PART 1 - ADDENDUM

- 1.1.1. This Addendum is issued to provide for modifications and/or clarifications during Bidding and forms part of Bid and Contract Documents for above Project.
- 1.1.2. Except as otherwise specified herein, or as shown on accompanying Drawings, work required by this Addendum shall be in accordance with Specifications dated January 31, 2025, Drawings accompanying same and previously issued Addenda.

UNIVERSITY OF TORONTO
**HEALTH & WELLNESS CENTRE
 AT KOFFLER RENOVATION**

SHEET NO:
A316

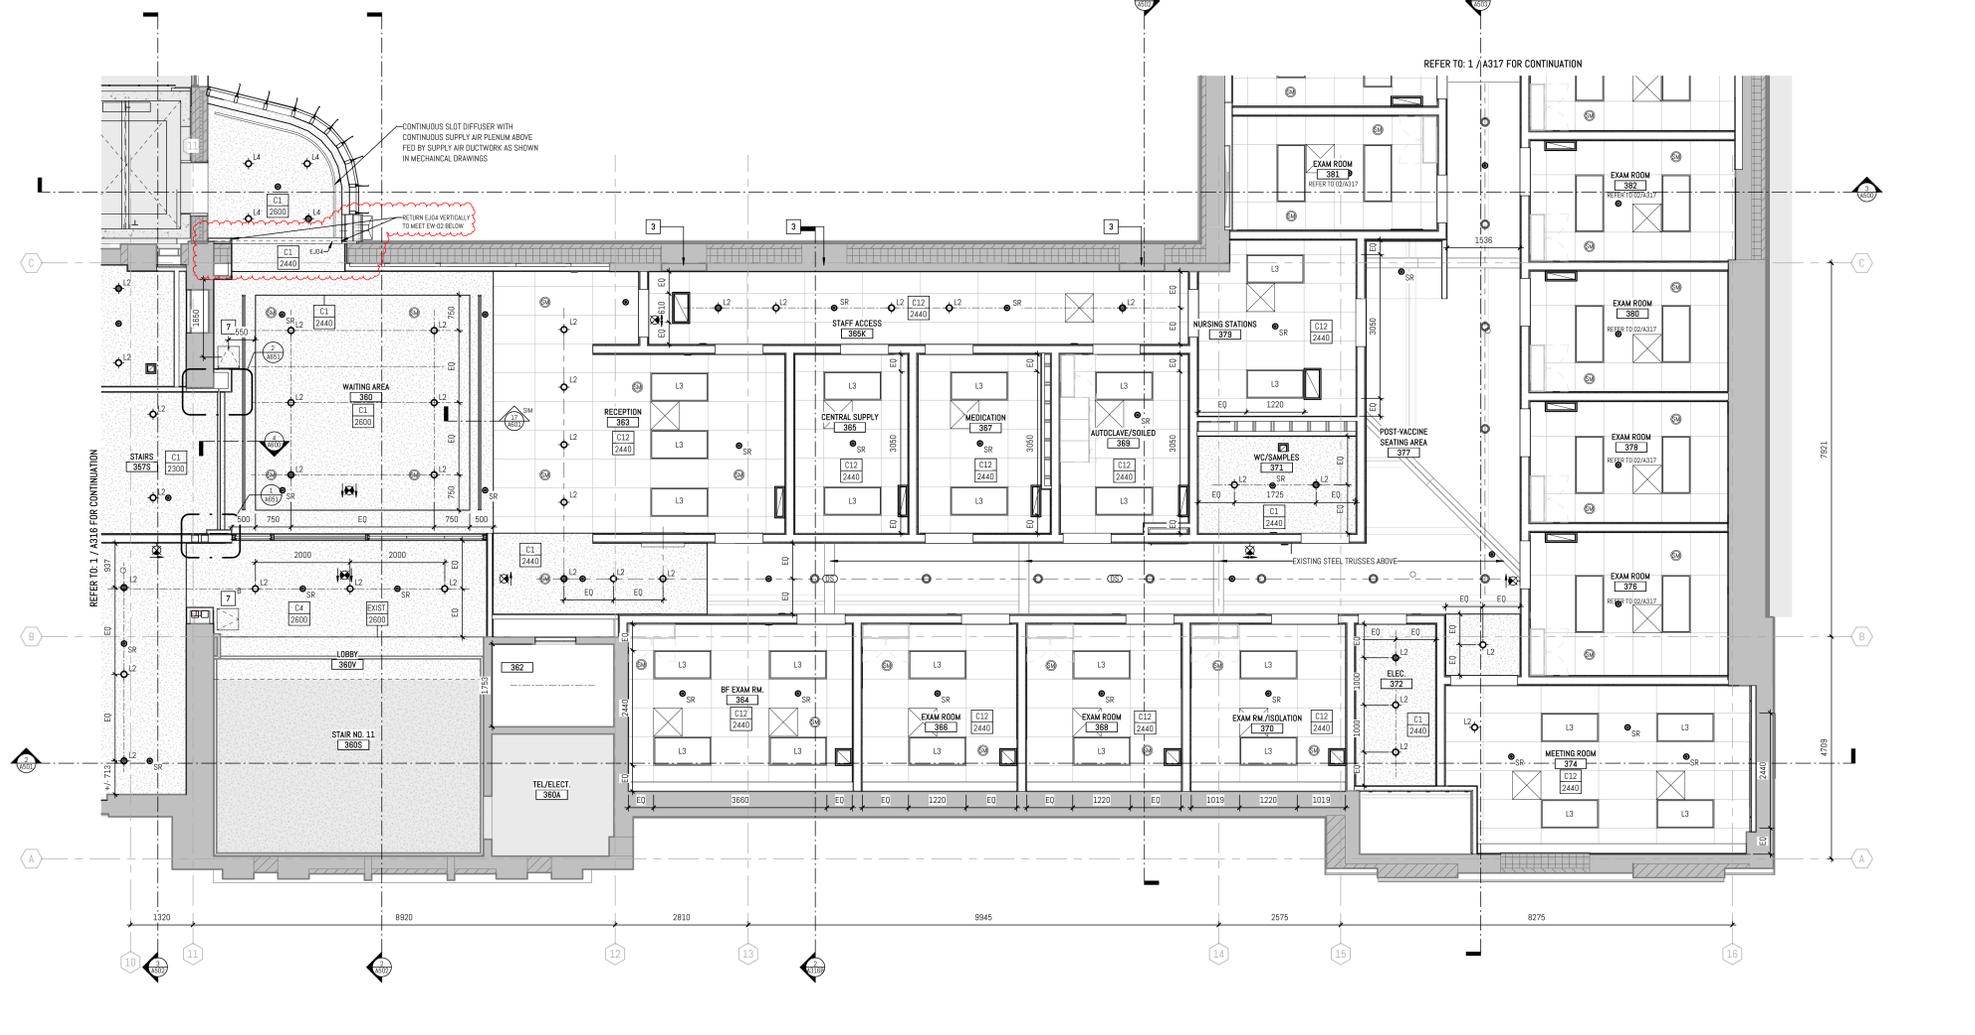
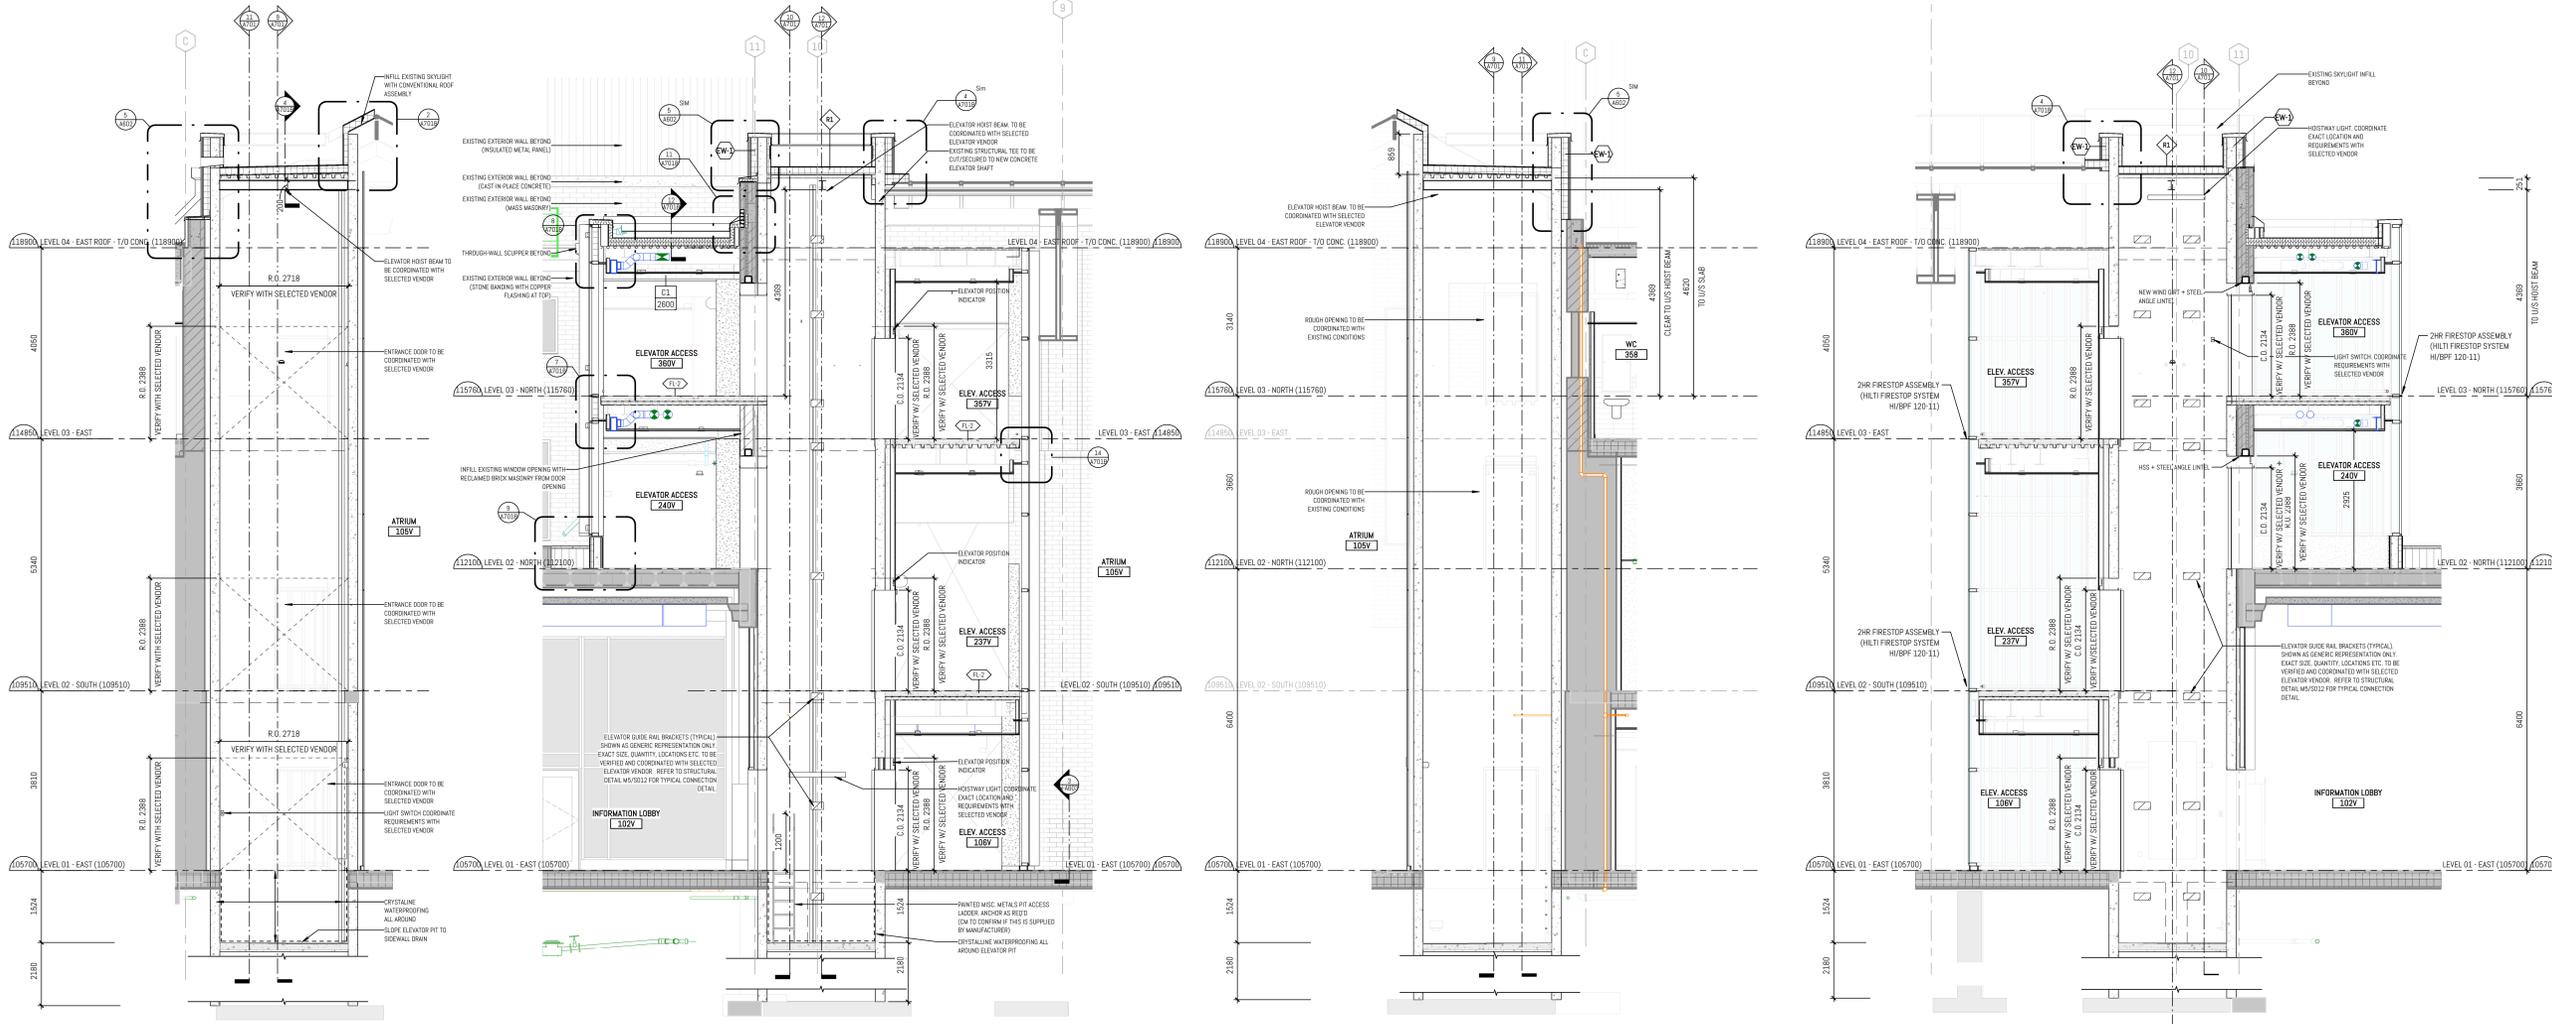
- 4.5.1. Drawing No. A316 attached is modified as follows:
- 4.5.1.1. Added ceiling expansion joint location at Elevator Landing.
